Addendum

Subject: Addendum to Agenda Item 6a: 1030 Young Street Apartments (DR 22-06)

Color site plan excerpt: south walkway crossing

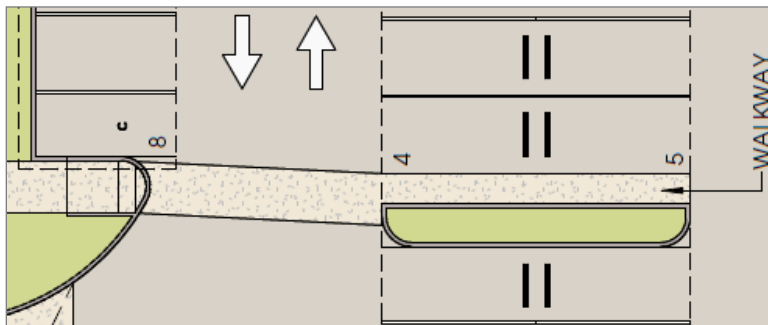
Staff first addresses variance request 5, which was to not have landscaped islands along the south sides of two walkway crossings in the central parking aisle. This was based on the application materials as they were.

After applicant and staff discussion leading up to the staff report, in exchange for staff recommending denial of request 5 but also conditioning variance request 4 (the request to have more than the maximum number of consecutive parking spaces between landscaped islands) to help the applicant fit in islands – including to allow the walkways to become narrower where they pass among parking stalls – the applicant agreed to and did revise the site plan to fit in landscaped islands along the south sides of the two walkway crossings.

If one considers there to be no variance request number 5, there would still be no change necessary to variance conditions of approval or the site plan.

Staff proposes no change.

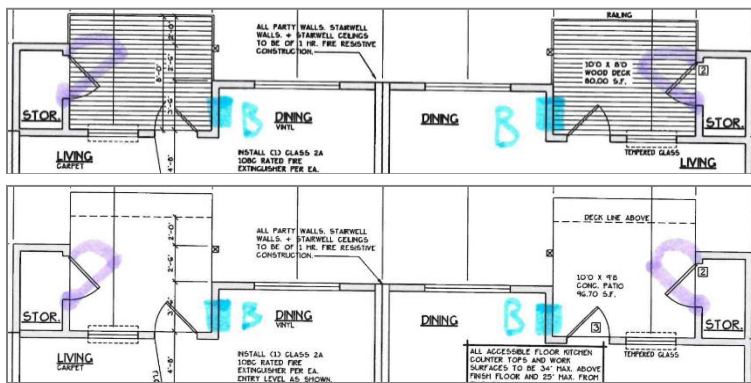
V15.a.(2), b., and g.(5) (Pages 24 & 25) – The awning heights, column design, and window provisions meets or exceeds minimum development standards and will have to meet building code standards not recognized by the WDO, these requests have serious structural implications. Additionally, adding windows where not required reduces interior functional use which was explained in our previous meetings. For these reasons we continue to object to these conditions.

“Columns, piers, and posts: For:

- (1) All excepting patios and balconies: Shaft min 8 inches square or diameter.
- (2) Any exposed wood columns, piers, and posts shall be finished/treated/varnished to protect from the elements and splinters.
- (3) Leasing office north entrance, shall be divided visually into clear areas of capital, shaft, and base. If the bases would have been concrete stubs, they shall be covered with brick matching that proposed for much of the ground floor walls.”

The condition applies only to the Building A leasing office and common room patio canopies. As mentioned on Attachment 102 p. 81, a purpose is that for canopy supports in the form of, “columns, piers, or posts, to have minimal architectural treatment by each having a clear capital, shaft, and base and to be thick enough to appear able to support the load above it and not appear spindly.”

Staff proposes no change.
